Subject: AIR TEMPERATURE WILL NOT CHANGE	Bulletin No: 07-003/15
	Last Issued: 11/17/2015

BULLETIN NOTE

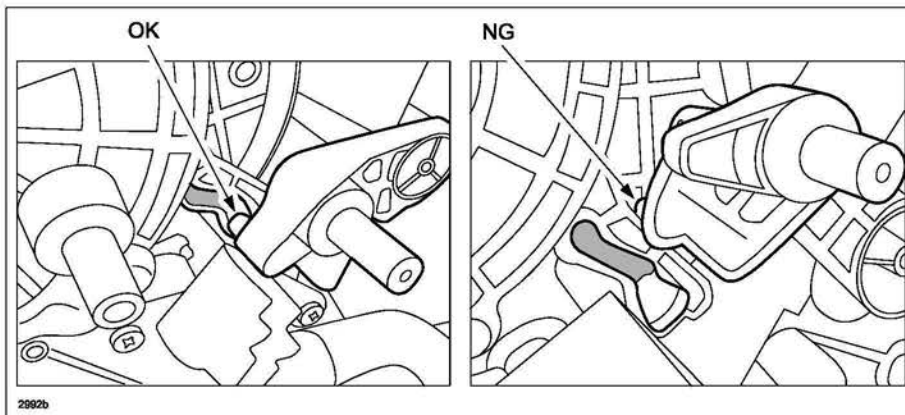
1. Verify customer concern.
2. Refer to the instructions on MS3 online or the Workshop Manual (section 07-40 CLIMATE CONTROL UNIT REMOVAL/INSTALLATION [MANUAL AIR CONDITIONER]) and check that the MIX LINK (Air mix link/Temperature control link) (A) is properly connected to the MIX DOOR CRANK (B) and works while rotating the temperature control knob.

- a. If it works, this Service Bulletin does not apply. Refer to the instructions on MS3 online or Workshop Manual for troubleshooting and repair.
 - b. If the MIX LINK is detached, proceed to the next step.
3. Replace the MIX LINK with a modified one. Refer to MS3 online or the Workshop Manual (section 07-11 A/ C UNIT DISASSEMBLY/ASSEMBLY). Make sure that the MIX LINK is fitted in the groove of the MIX DOOR CRANK and will not come out with movement.
